HUNTSVILLE UTILITIES SOUTHEAST WATER TREATMENT PLANT

To: All Plan Holders

From: Tetra Tech

Date: December 10, 2014

STANDARD TRENCH
DETAIL
(SHEET C-9501, VOLUMES 3A & 3B)

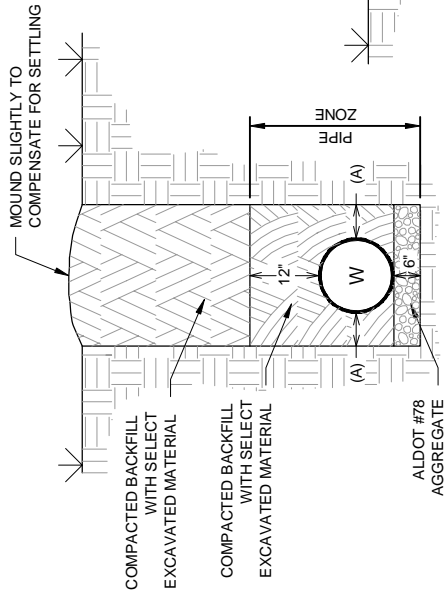
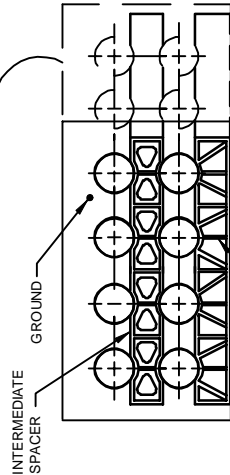
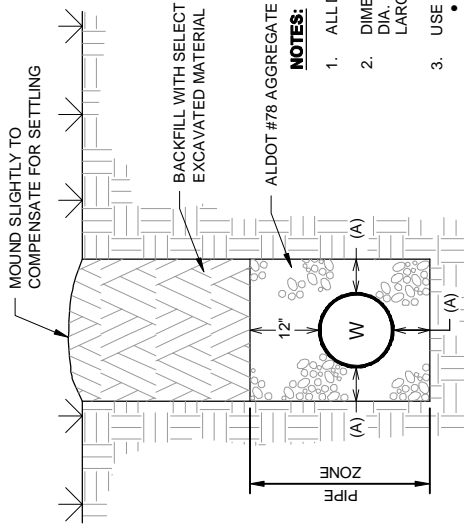
Item No. 6: **Sheet C-9501, Detail 2.** Replace the current version of Detail 2 provided under Addendum No. 2 with the revised detail (attached). This detail replaces all other trench and ductbank details and is applicable to pipes, power conduits, communication/control conduits, and ductbanks. It also revises the position of the location tape set forth in revised Section 31 23 23.15, which was issued under Addendum No. 2. Bidders shall note that all other requirements set forth in revised Section 31 23 23.15 remain valid.

S-8303
Copyright: Tetra Tech
Bar Measures 1 inch

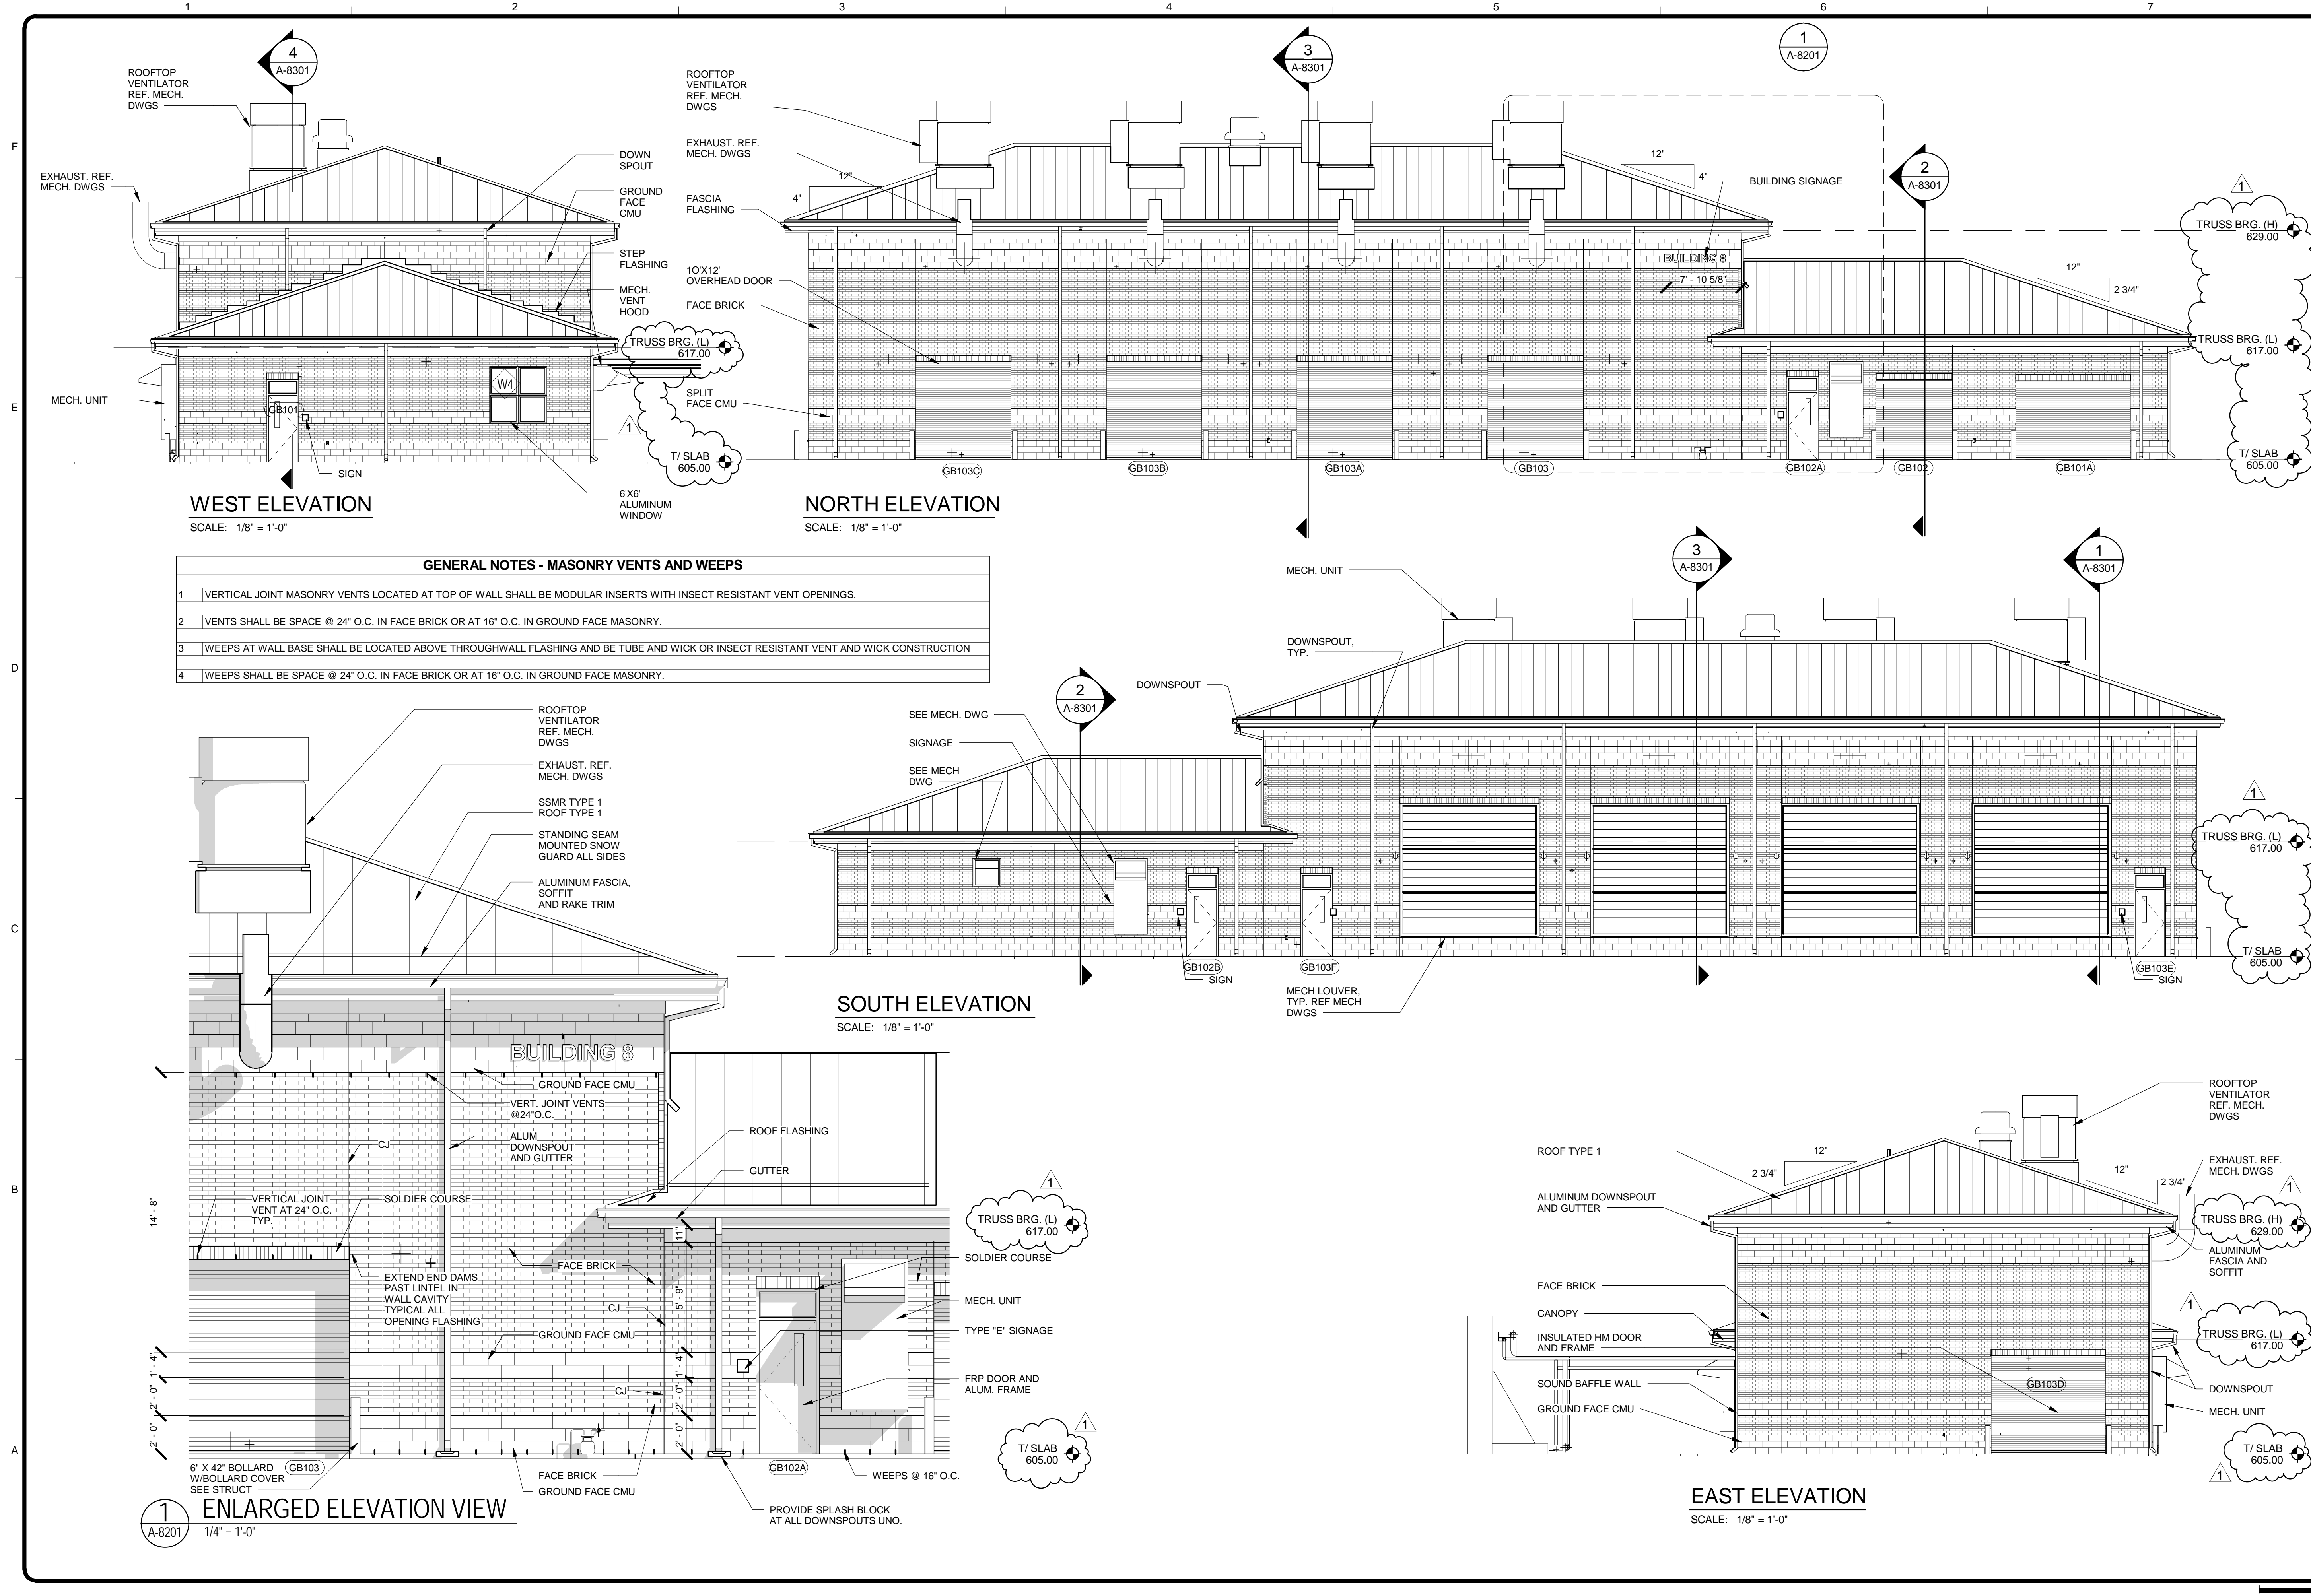
Item No. 17: Sheets S-8101, S-8102, S-8301, S-8302, S-8303, A-8201, A-8301, and A-8302. Replace the existing sheets with revised sheets (attached) noting revised elevations.
